Southern California Edison Company

Subject: Docket No. 50-206
Provisional Operating License No. DPR-13
Amendment No. 77
San Onofre Nuclear Generating Station
Unit 1

The purpose of this letter is to inform you that several corrections are required to Figures 6.2.2.2 and 5.2-2 to accurately reflect the San Onofre Unit 1 operating staff. These corrections are as follows:

FIGURE 5.2-2 SAN ONOFRE NUCLEAR GENERATING STATION (UNIT 1) ORGANIZATION

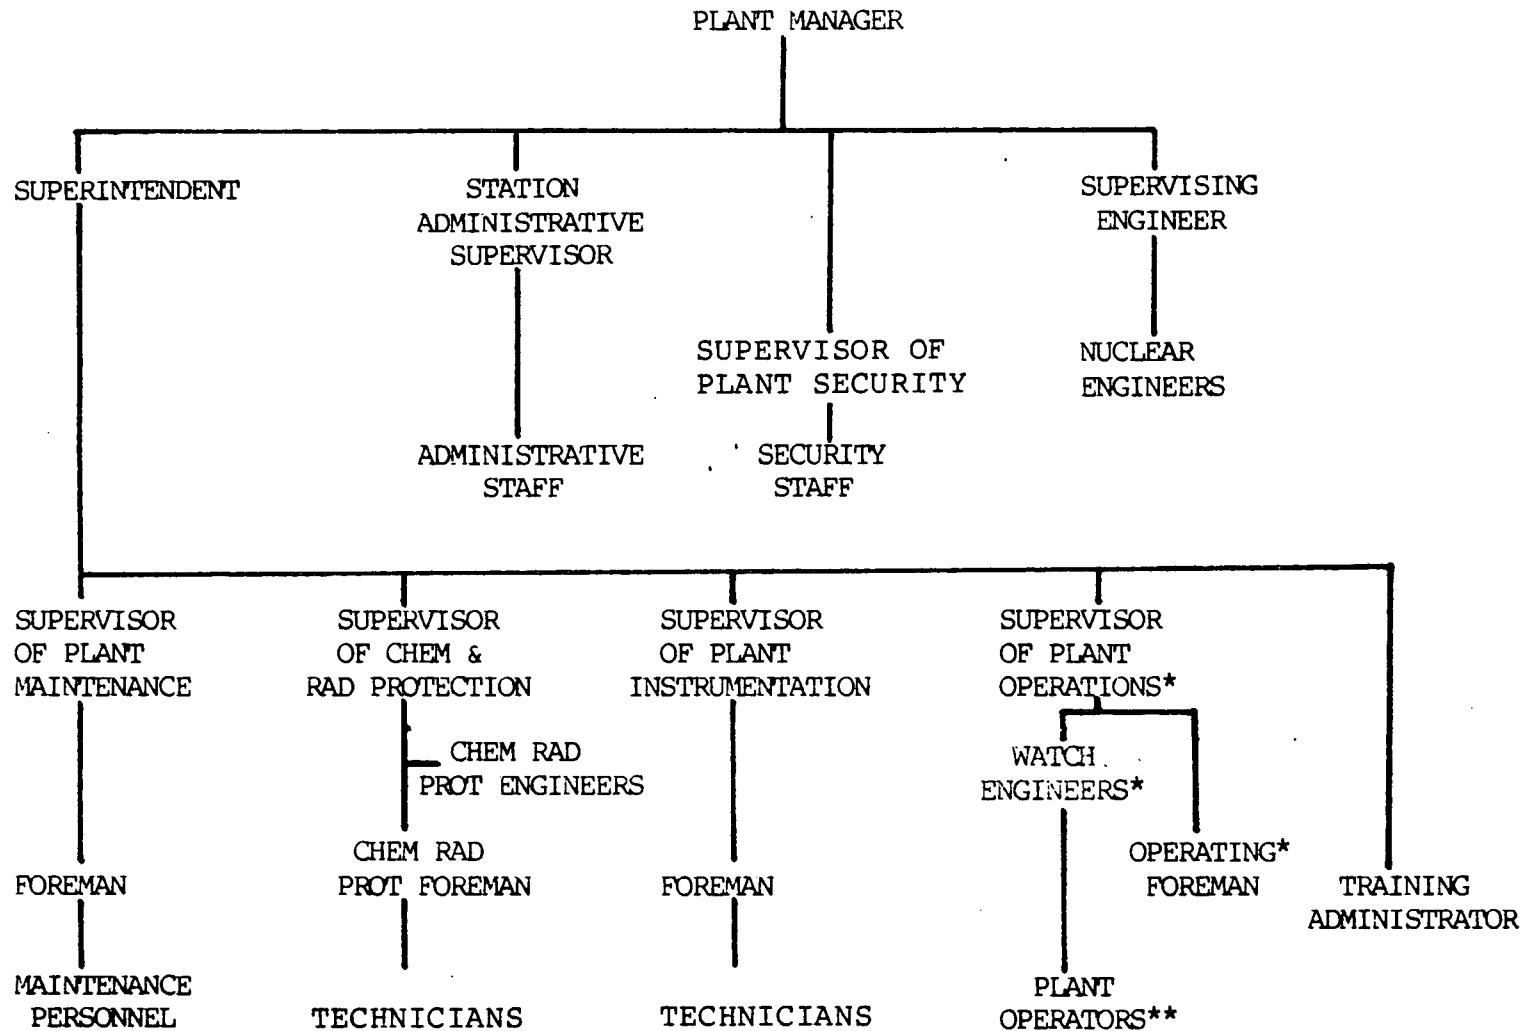
1. Chem Rad Protection is replaced by Technicians, and
2. Instrument Test Technicians is replaced by Technicians.

As requested by members of your staff, enclosed are forty copies of each of the corrected Figures 6.2.2.2 and 5.2-2 which supersede the corresponding figures of Proposed Change No. 77.
